Road Safety Audit Review

Browns Trace Road

Town of Jericho

Browns Trace Road Road Safety Audit Review Review Report

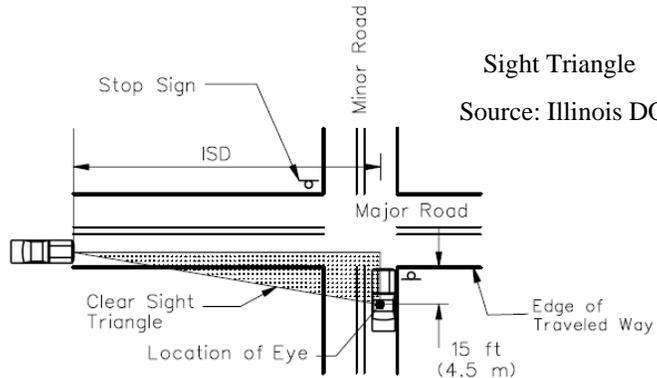
Limited corner sight distance to the left when stopped at the Plains Road approach

Promote a clear sight triangle as recommended by AASHTO

From the edge of the road, measure 15 ft back (this is the vertex of the sight triangle)

For an estimated traveling speed of 25 mph, "ISD" is 280 ft

For an estimated traveling speed of 40 mph, "ISD" is 445 ft

Anything within the triangle area such defined should be as much as possible trimmed/removed/ relocated

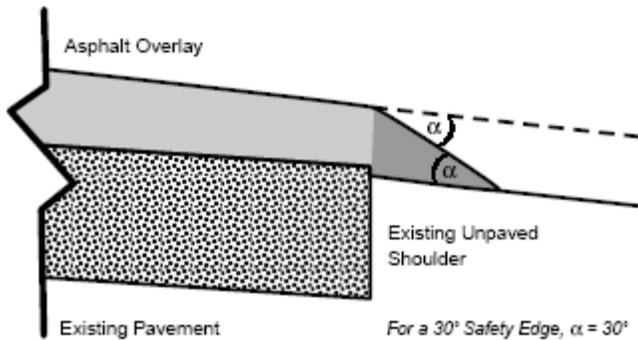
Potential of edge drop-offs that could eventually cause motorists to lose control

The edge drop that is being created could cause a motorist that went of the road to lose control when trying to get back on the pavement

Drop-offs of three or more inches are unsafe if the roadway edge is at a 90-degree angle to the shoulder surface

Pull up the shoulder area where applicable

Consider specifying a 30-35 degree angle asphalt fillet (called the "Safety Edge" by FHWA) in the contract specification of the next paving project for this road

Appendix A –Proposed Signage

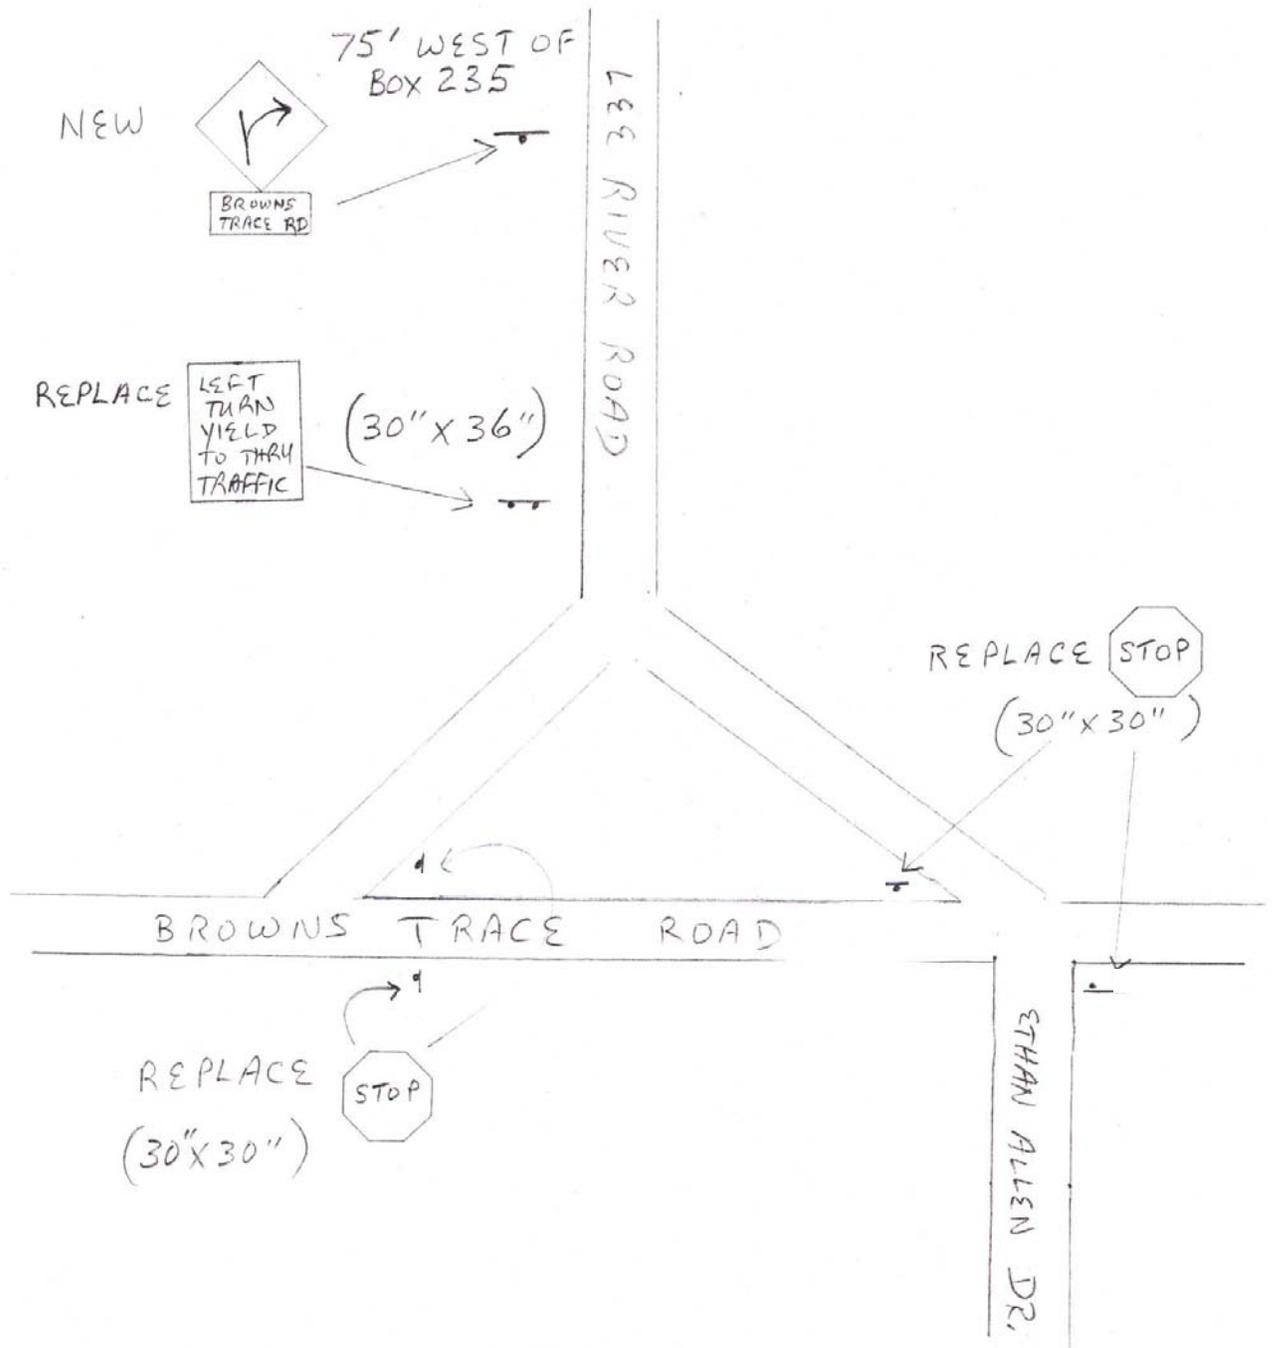
NEW  PUT IN PLACE OF CURRENT "FIRE EQUIPMENT ENTERING"

REPLACE  AND MOVE 25' NORTH OF POLE 349 A 89

NEW  ±150' SOUTH OF SIGN: ETHAN ALLEN TRAINING SITE

REPLACE  AND MOVE OPPOSITE 35 MPH SIGN

NEW  (30" x 30") 83' SOUTH OF POLE 349 A 89

REPLACE  AND MOVE ACROSS FROM POLE 30C
